Pulaski County Schools
Energy Savings and Performance Contract
Addendum #2
March 25th, 2022

CMTA Contact:	Megan Brangers
Email:	MBrangers@cmta.com
Cell Phone:	502-919-1521

The following information supersedes or is in addition to information released in the Contract Documents dated March 11th, 2022 and addendum 1 dated March 18th, 2022.

E4-2.1B

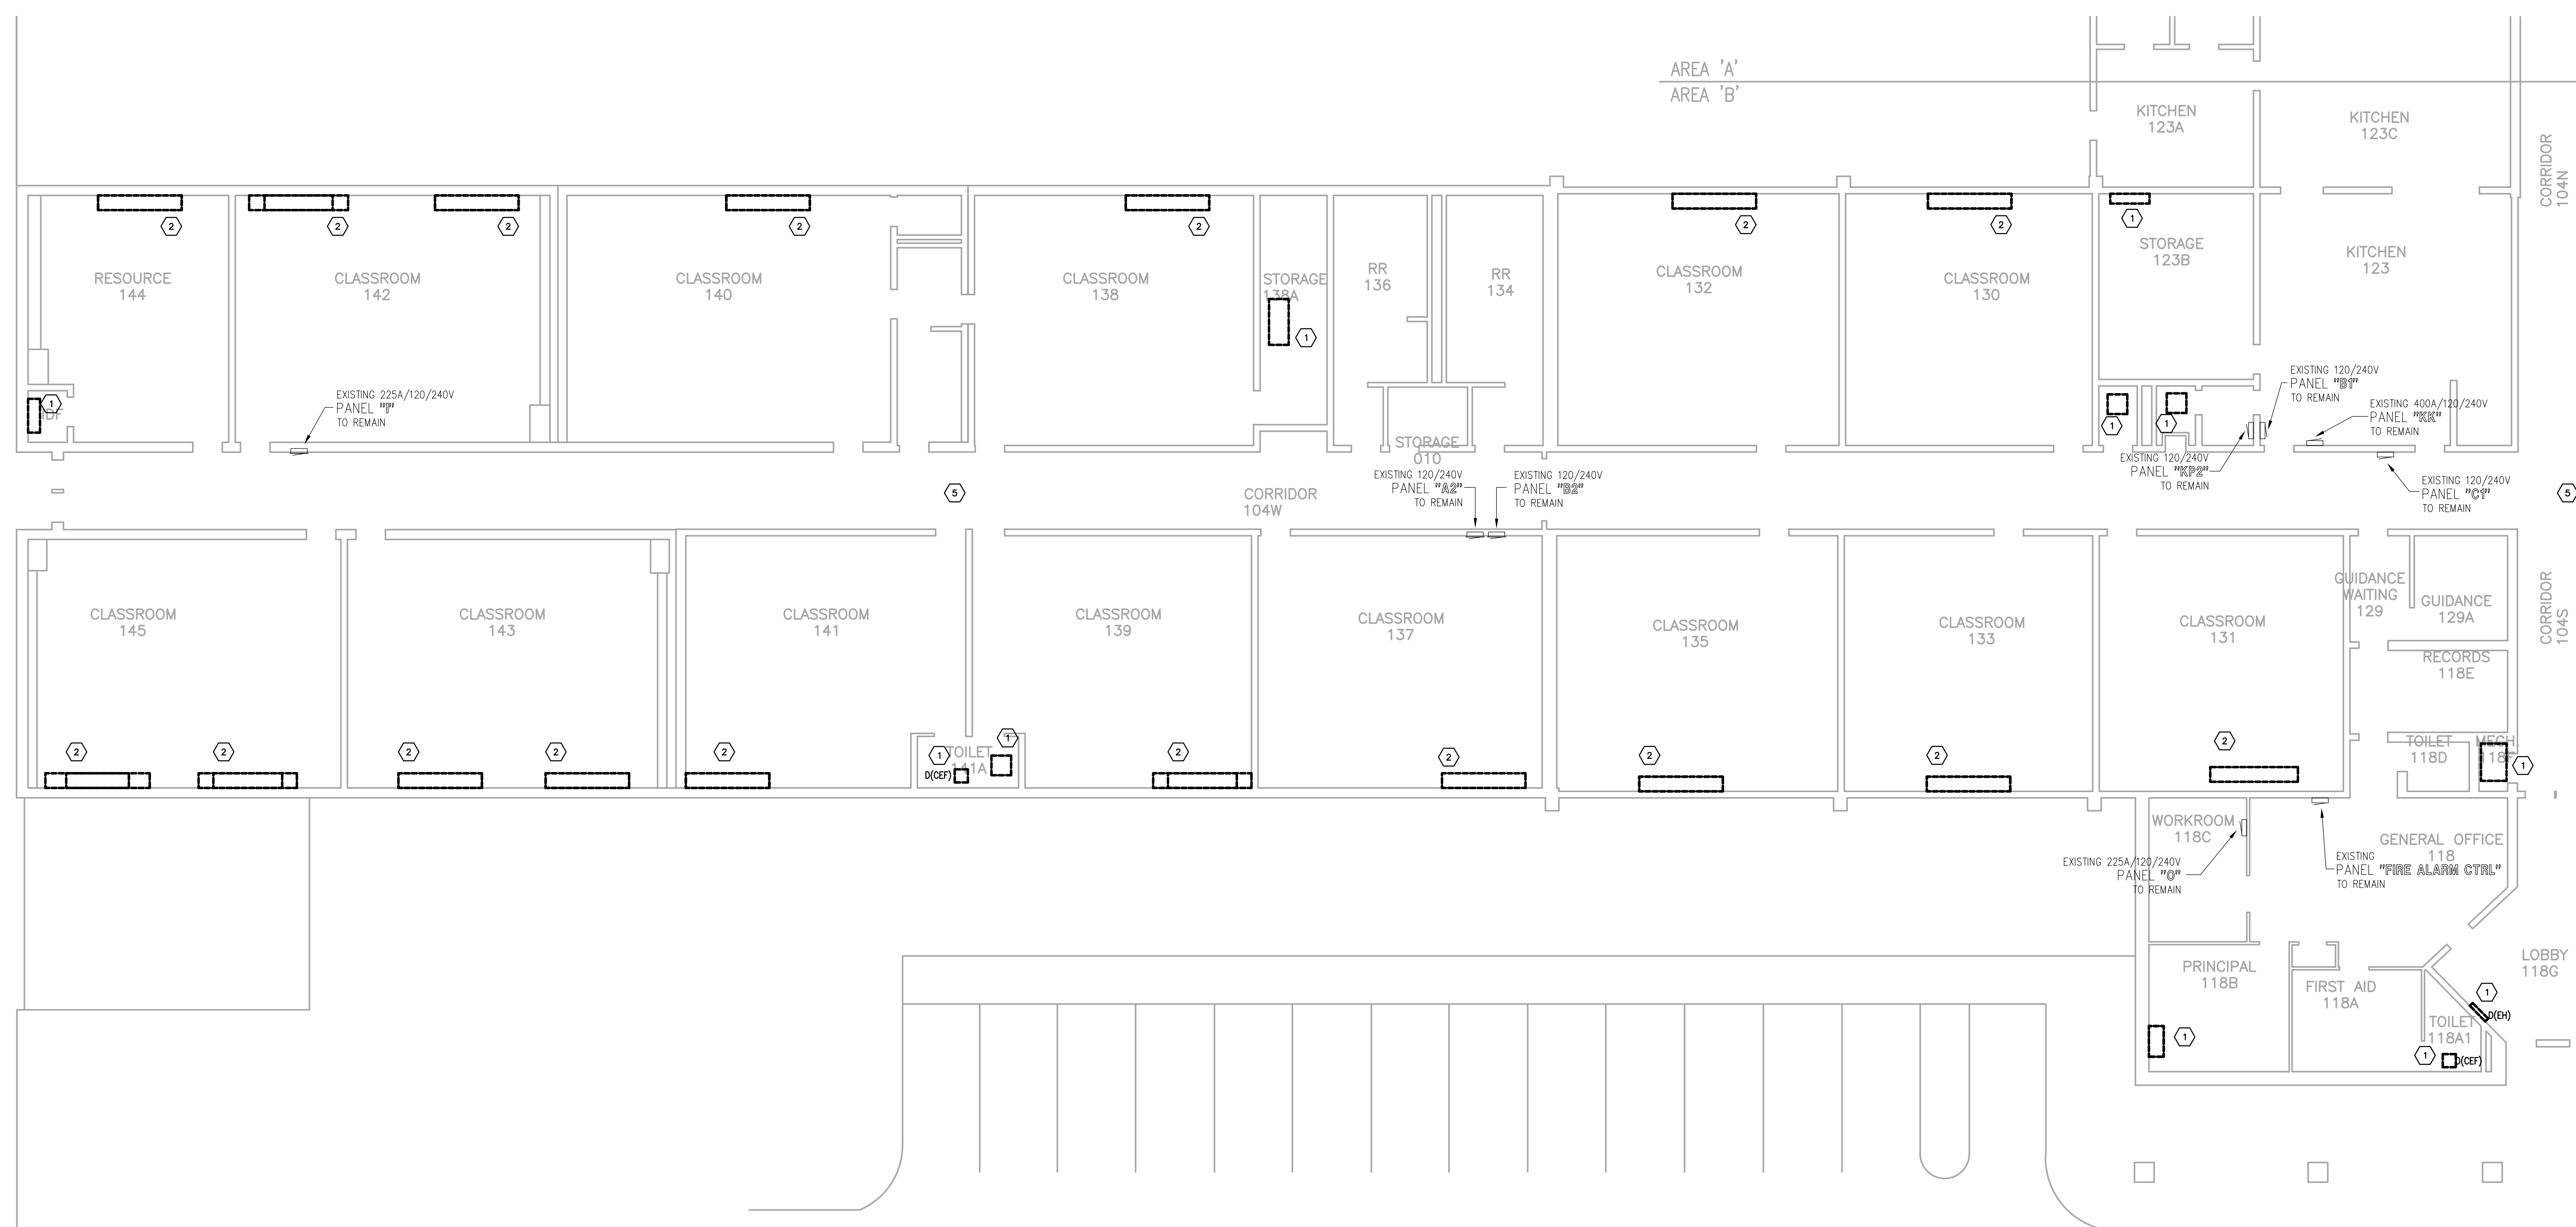
7. Drawings E4-2.1A
 - a. Refer to revised drawing.
 - i. Additional platform equipment demolition indicated.
8. Drawings E4-2.1B
 - a. Refer to revised drawing

- i. Tag Note 5 added. Remove abandoned lights above corridor ceilings.
9. Drawings E4-2.1C
 - a. Refer to revised drawing
 - i. Tag Note 5 added. Remove abandoned lights above corridor ceilings.

E4-2.1C

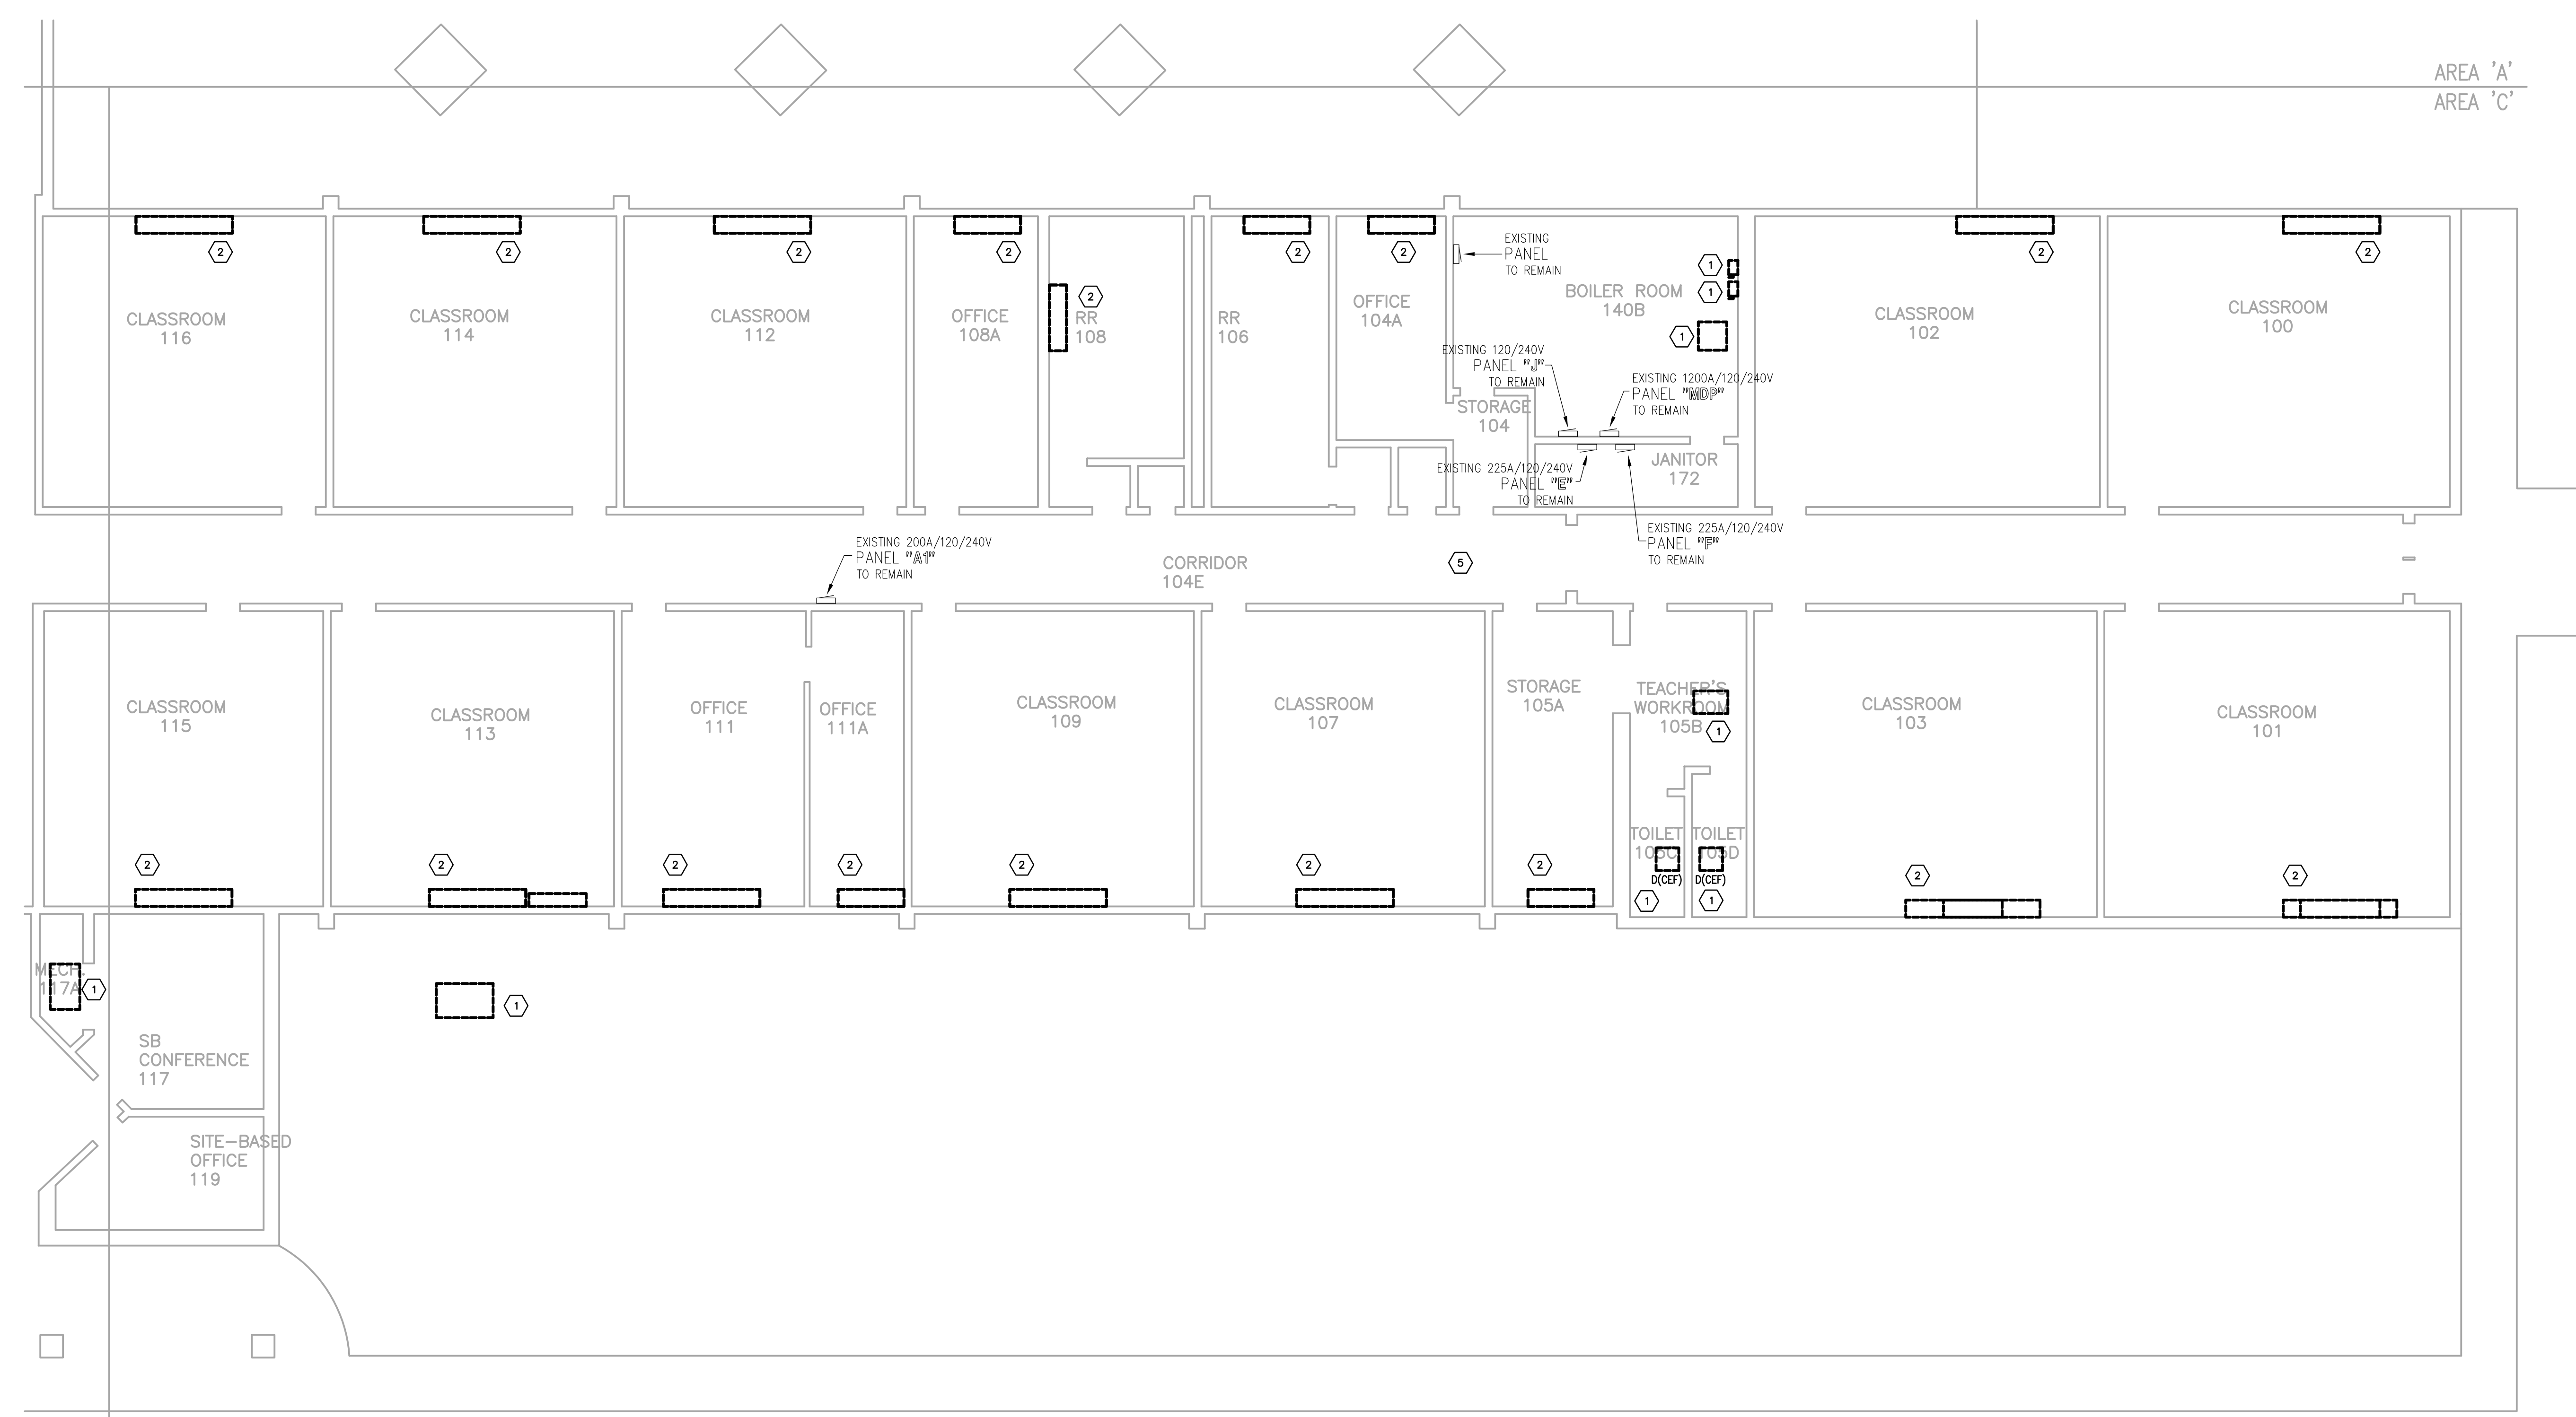
- ii. Boiler Room 140B - Remove connections to disconnects/pumps as indicated.
10. Drawings E4-2.2
 - a. Refer to revised drawing.
 - i. (3) RTU indicated with tag note 4 conduit/wiring are permitted for connection to replacement equipment as indicated. Replace breaker per new work plans.

E4-
3.1A

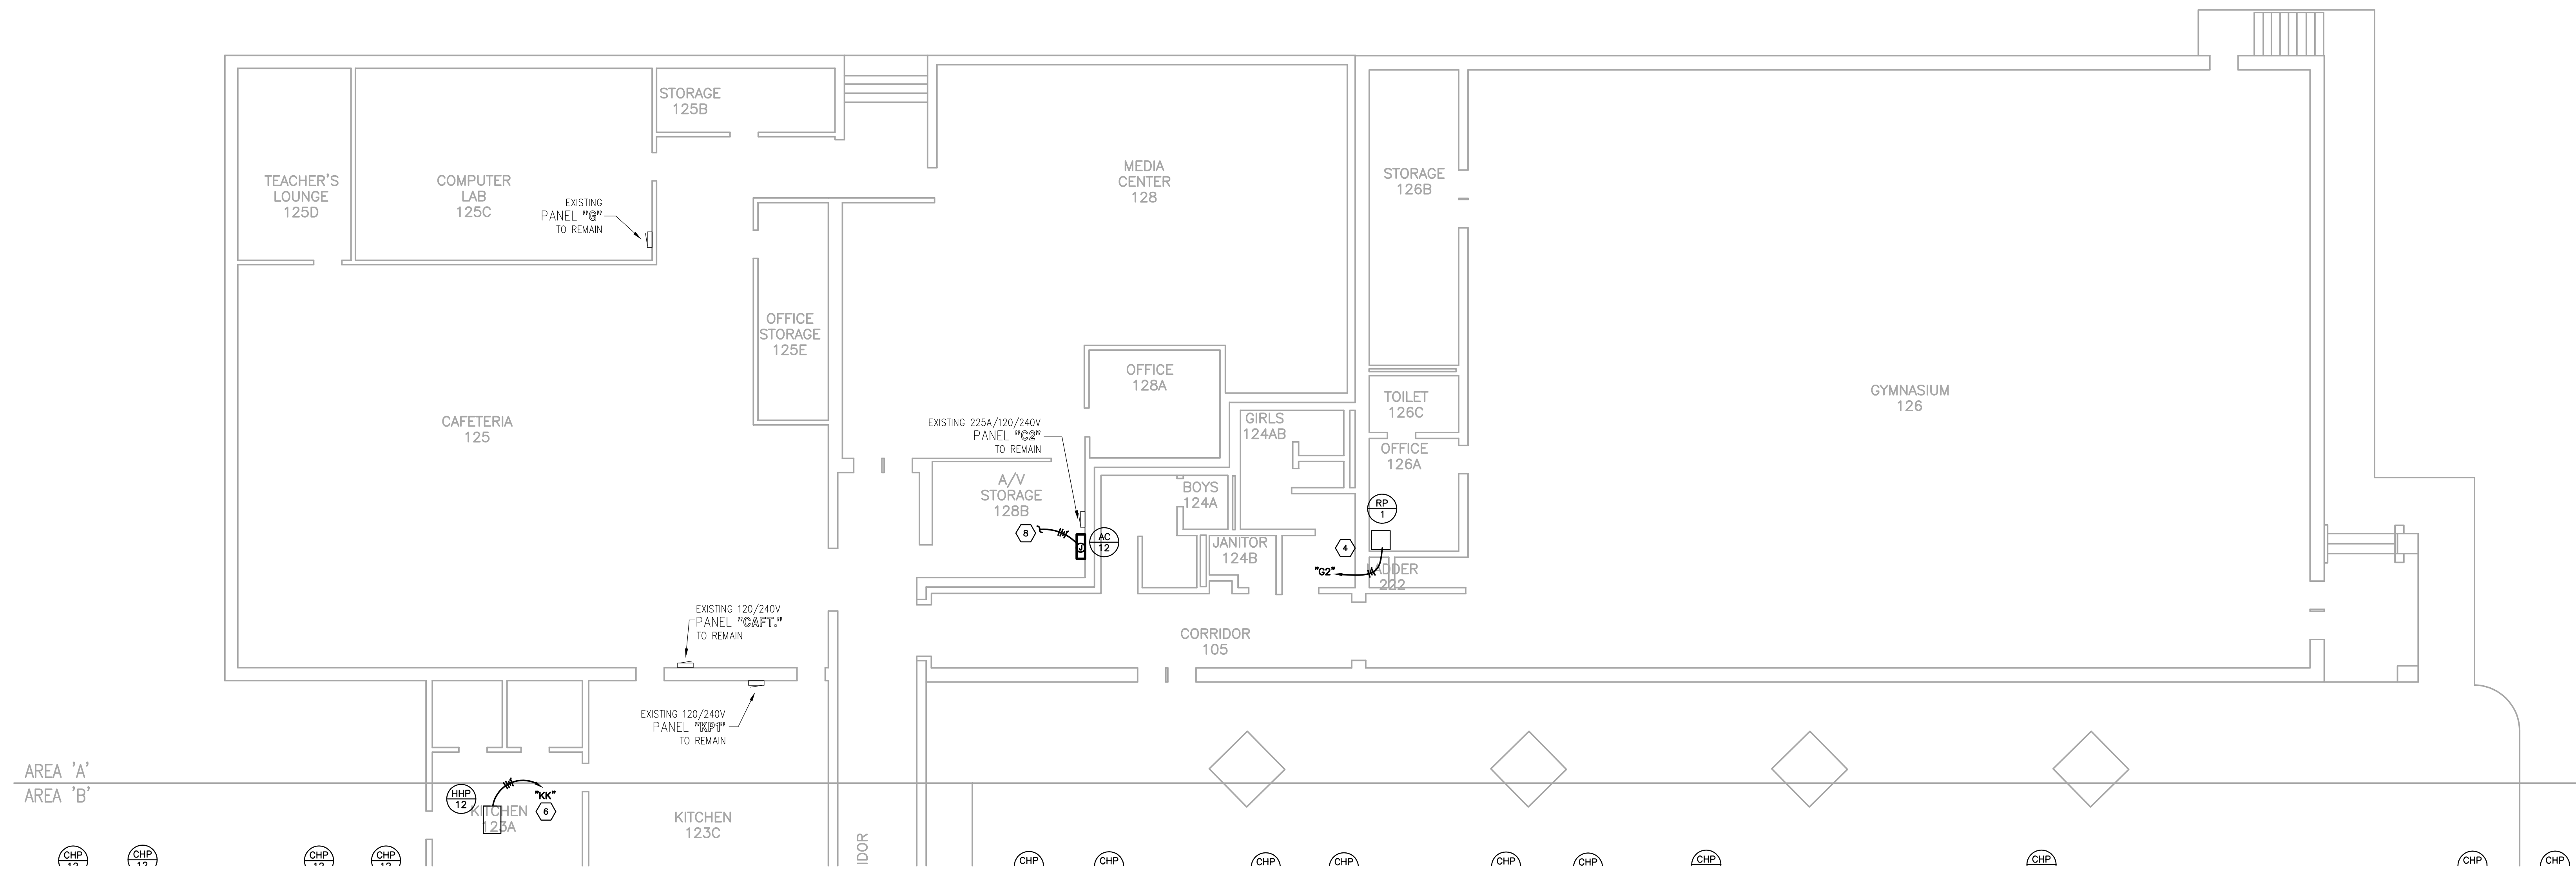
11. Drawings E4-3.1A
 - a. Refer to revised drawing.
 - i. General Note 'I' added to plans.
 - ii. See updated tag notes - Conductor quantity updated for 2P & 3P circuits.
